**From:** Mark Plotkin <nspktr@aol.com>  
**Sent:** Friday, September 9, 2022 3:30 PM  
**To:** Lee, Chris  
**Cc:** Murphy, Michael (Alderman); Dimitrijevic, Marina; Bauman, Robert; Perez, Jose; Stamper II, Russell  
**Subject:** St. Mark's Parking Garage

It has come to my attention that there is a significant discrepancy in the design submissions for the underground parking garage in the proposed parking garage on Hackett Avenue.

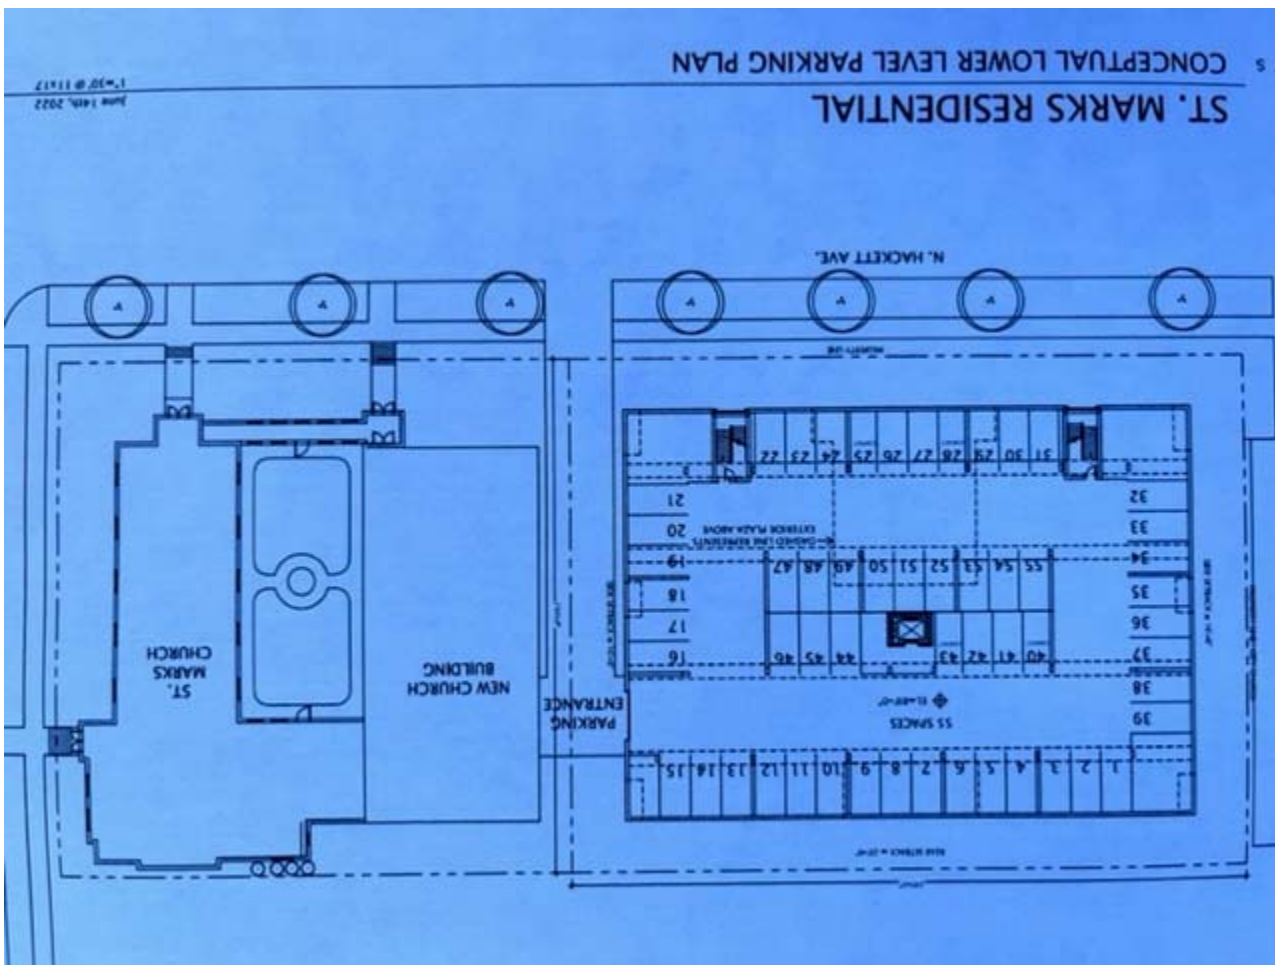
As you can see in the first drawing below, the original design concept called for 55 parking spaces for 55 dwelling units. This design was submitted to the Historic Preservation Commission in July of this year. There was a lot of concern expressed by neighbors about the impact this new building would have on street parking in the area.

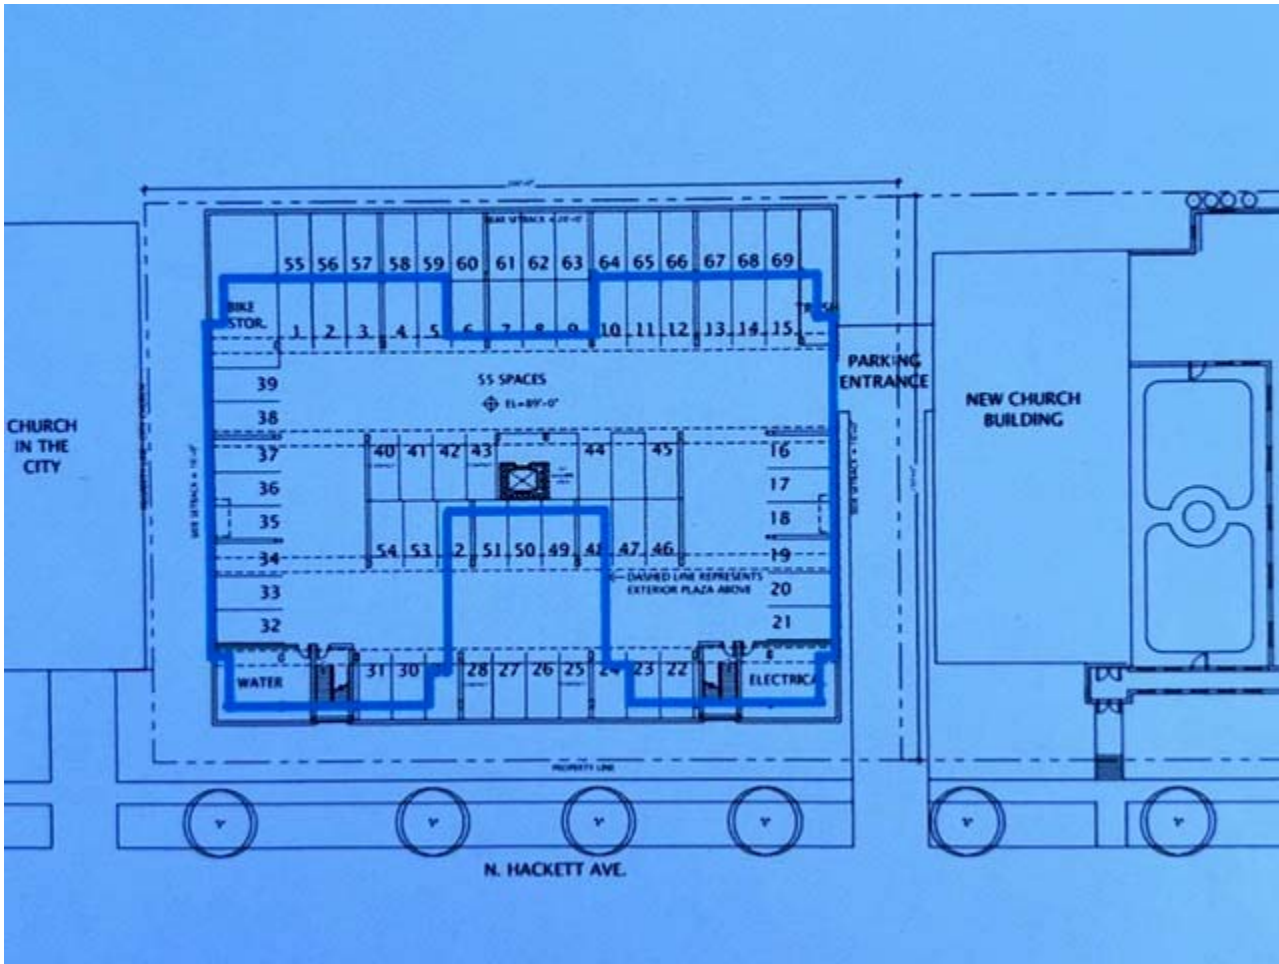
neighborhood parking situation. This second plan, below, adds 14 spaces to create a total capacity of 69 vehicles.

As you can see, the new plan takes the foundation and walls of the parking structure well outside the (blue line) boundaries of the setback requirements for this building project. In fact, it appears that the east foundation extends almost to the property line of the residential lots to the east. It would seem to me that this is an admission by the development group that adequate provisions for parking cannot be provided in this design because the building is **too large to begin with**.
